STAFF REPORT

SUBJECT: H-2024-0060
Lennon Pointe – PP, PS

LOCATION: 1515 W. Ustick Road, at the southeast corner of N. Linder Rd. and W. Ustick Rd., in the NW 1/4 of Section 1, T.3N., R.1W. (Parcel #S1201223115)

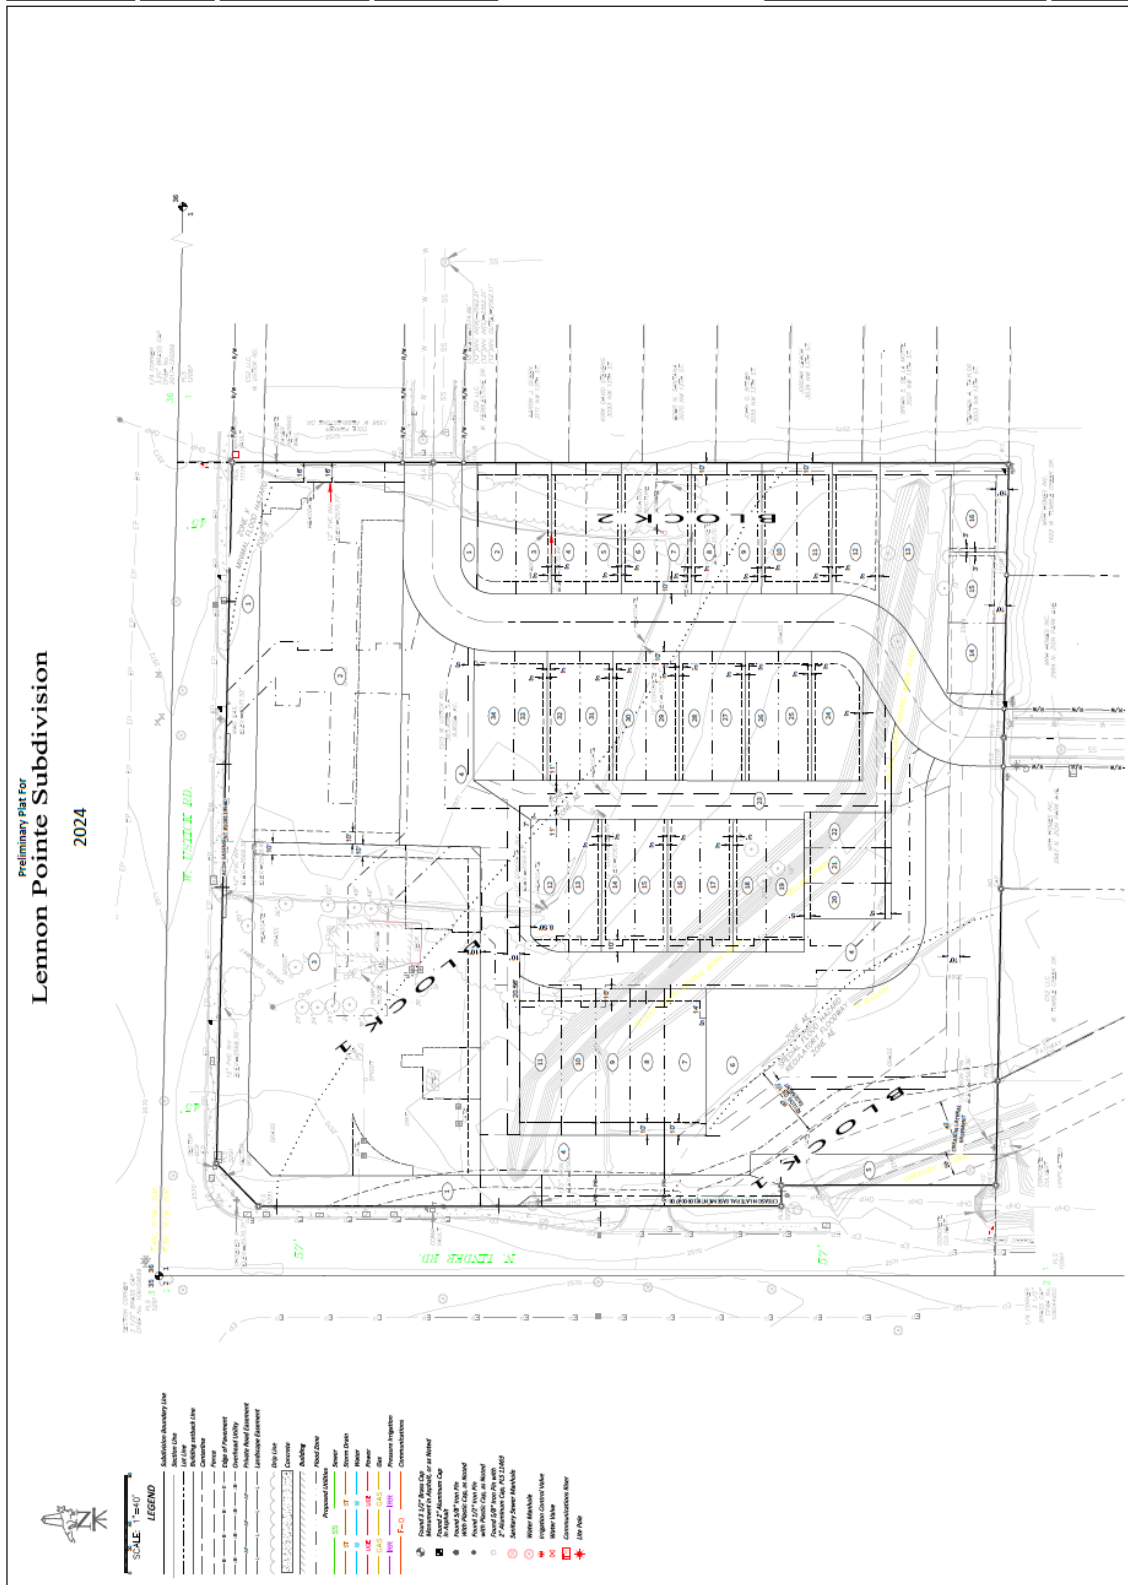
2. The final plat shall include the following revisions:
 - a. Widen Lots 14-16, Block 2 to accommodate the minimum front setback of 20-feet to the face of garage on these lots.

- b. Depict a minimum 20-foot wide perpetual ingress/egress easement on Lot 13 for the common driveway and include a note for the easement requiring maintenance of a paved surface capable of supporting fire vehicles and equipment in accord with UDC 11-6C-3D.8. Alternatively, a separate 20-foot wide common lot could be included for the common driveway.

- c. Plat note #7 includes incorrect common lot numbers; revise accordingly and remove the portion pertaining to the common driveway.
 - d. Depict a 26-foot wide easement for the private street on Lot 4, Block 1 and include a note granting an ingress/egress/cross-access easement to all lots in the subdivision to use the private streets on Lot 4, Block 1.

- g. The private street shall be a loop off the local street (i.e. N. Zion Park Ave./W. Pebblestone Dr.) and shall not extend to the west of N.W. 15th Ln. along the north side of Lot 11, Block 1; the private street shall terminate on the west side of N.W. 15th Ln.

- h. Depict an access easement for the driveway proposed via N. Linder Rd. to the commercial property on Lot 3, Block 1 and for the driveway along the north side of Lot 11, Block 1 between the townhomes and commercial lot; the easement should grant access to all lots within the subdivision.

C. Common Driveway Exhibit

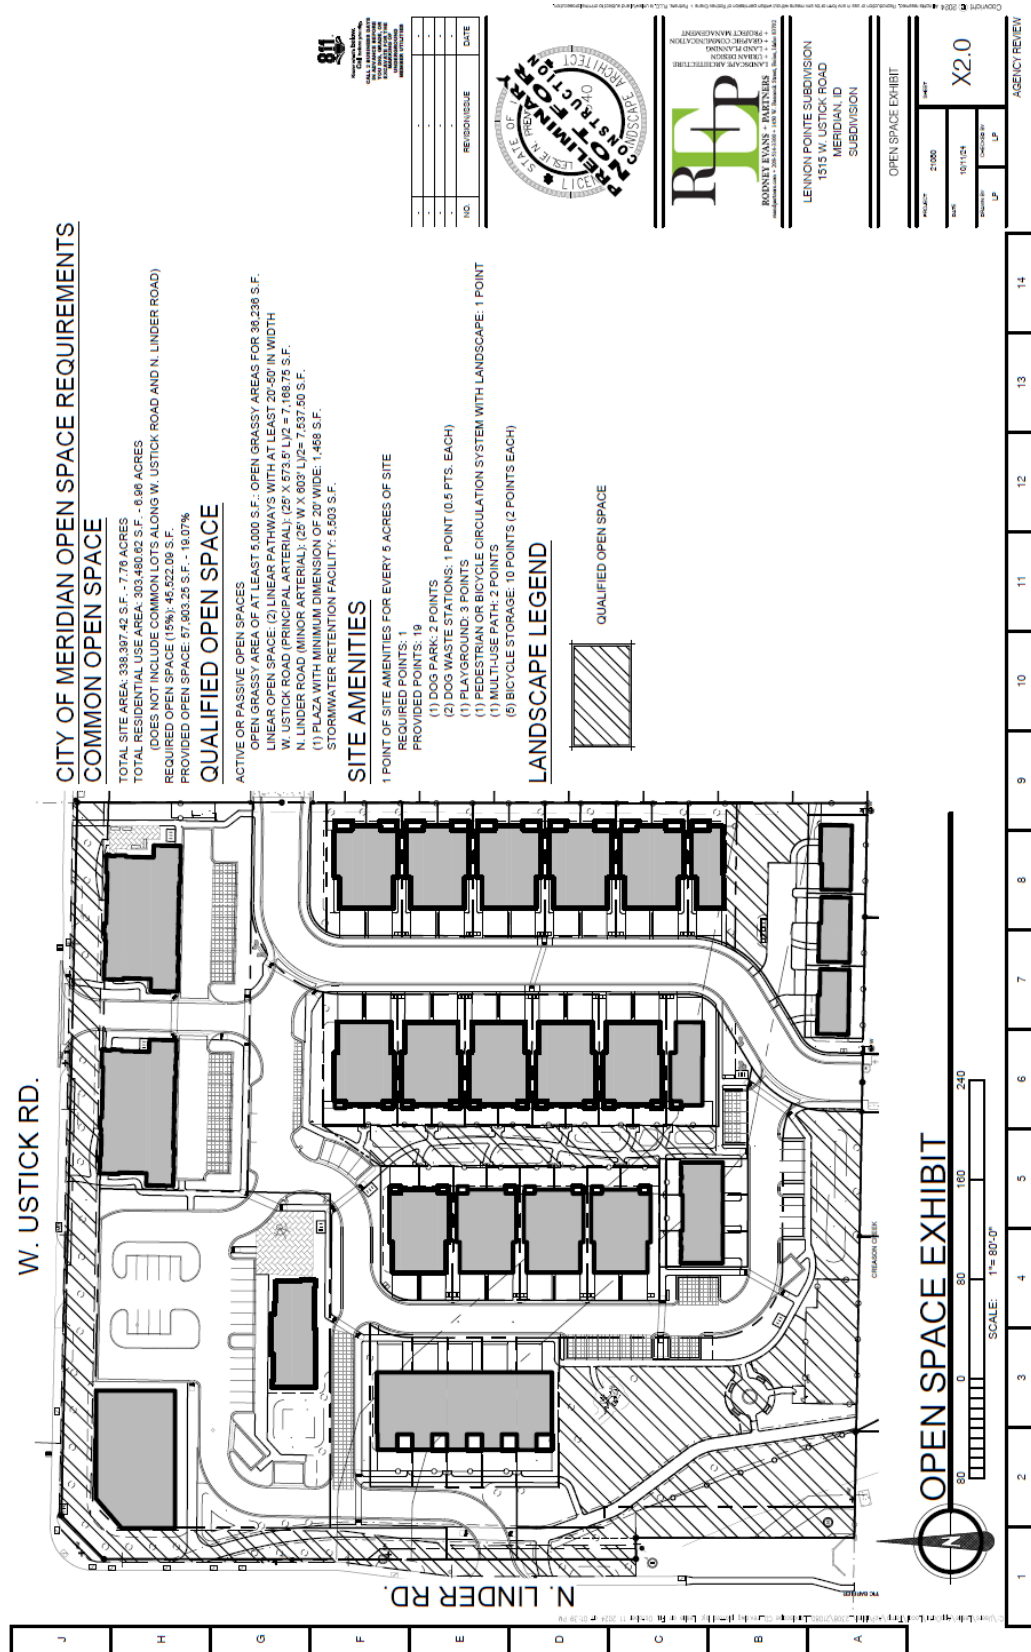
A common driveway is proposed on Lot 13 off N. Zion Park Ave., a local street, for access to the single-family homes proposed on Lots 14-16, Block 2 at the southeast corner of the site as shown in the exhibit in Section VII.C below. The driveway complies with the standards for such listed in UDC 11-6C-3D pertaining to maximum number of dwelling units to be served by the driveway and the number of units located on one side of the driveway, and the minimum width and maximum length standards. The exhibit depicts the proposed building envelopes with building setbacks – the side, rear and front setback to living area comply with the standards but the front setback to garage is below the minimum 20-foot standard – a portion of the 20-feet is depicted on the adjacent common lot where the common driveway is located. **The plat should be revised to reflect wider building lots to accommodate the front setback to garage on the building lot so that parking pads in front of garages are on privately owned lots rather than common lots. A minimum 20-foot wide perpetual ingress/egress easement should also be depicted on Lot 13 for the common driveway (or the driveway may be placed in a separate common lot), and a plat note should be included for the easement, which requires maintenance of a paved surface capable of supporting fire vehicles and equipment.**

- 7. A revised common driveway exhibit shall be submitted with the final plat application that reflects the revisions to the plat noted above.
 - 8. A floodplain development permit shall be required prior to any site work occurring on the property.

E. Open Space Exhibit (date: 10/11/2024) & Amenity Detail

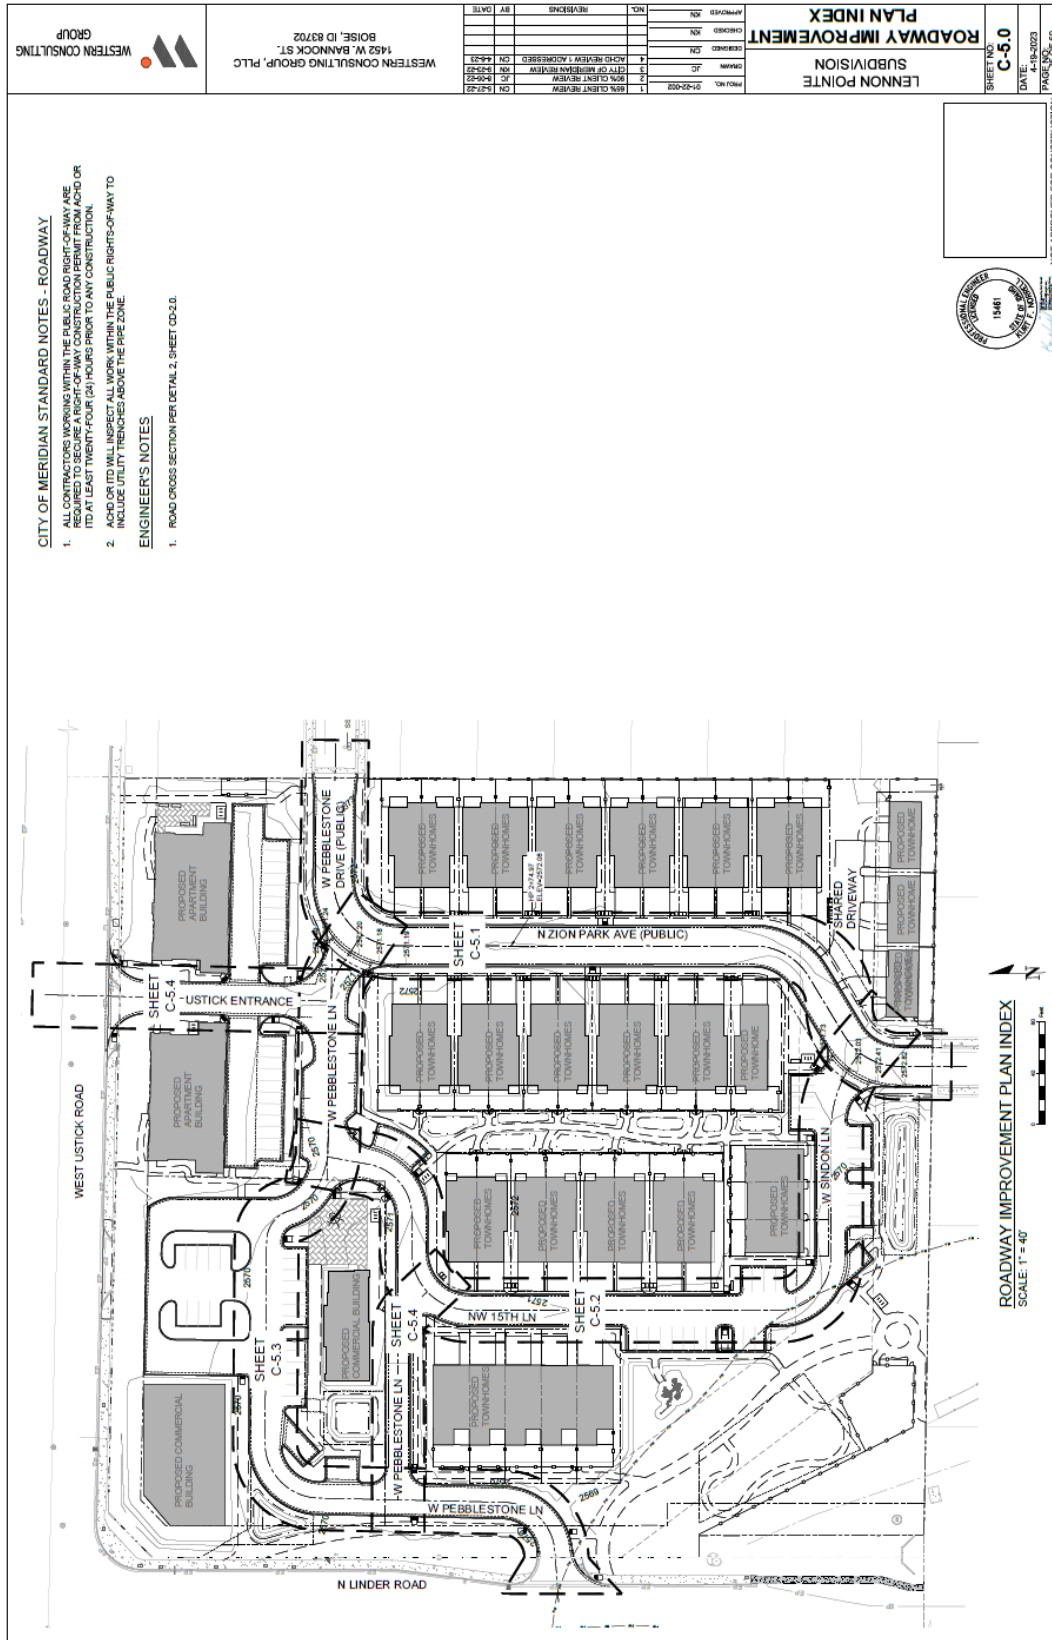
Based on 6.96-acres, a minimum of 1.05-acres of qualified open space is required; the open space exhibit submitted with this application, included below in Section VII.E, depicts a total of 1.33-acres (or 19.07%). Proposed open space consists of linear open space exceeding 20' x 50' in area with an access at each end improved with landscaping, open grassy areas exceeding 5,000 square feet in area, 50% of the arterial street buffers along Linder & Ustick Roads, stormwater retention facility, and a plaza with a minimum dimension of 20' in all directions, which meets and exceeds UDC standards.

The applicant proposes amenities consisting of a dog park with a dog wash station (2 points), two (2) dog waste stations (1 point), a tot lot with commercial grade play equipment (1 point), a short segment of multi-use pathway, internal pedestrian/bicycle circulation system with landscaping and (5) bicycle storage exceeding the minimum standards. The dog park, dog waste stations and tot lot should comply with the associated standards for such in UDC 11-3G-4C included below; the landscape plan (or a detail) submitted with the final plat application should demonstrate compliance with these standards.

The dog park should include bags for dog waste disposal, a double entrance gate, benches and fencing to enclose a minimum of 5,000 square feet and secured open space for an off-leash dog park. The waste stations should be installed in the ground fixture with waste disposal bags and trash receptacle. The tot lot should have commercial grade play equipment scaled and designed for the use and safety of younger children; benches for seating should be nearby.

- b. Include details that demonstrate compliance with the Quality of Life amenity standards for the dog park and dog waste stations in UDC 11-3G-4C; and with the Recreation Activity Area amenity standards for the tot lot in UDC 11-3G-4D.
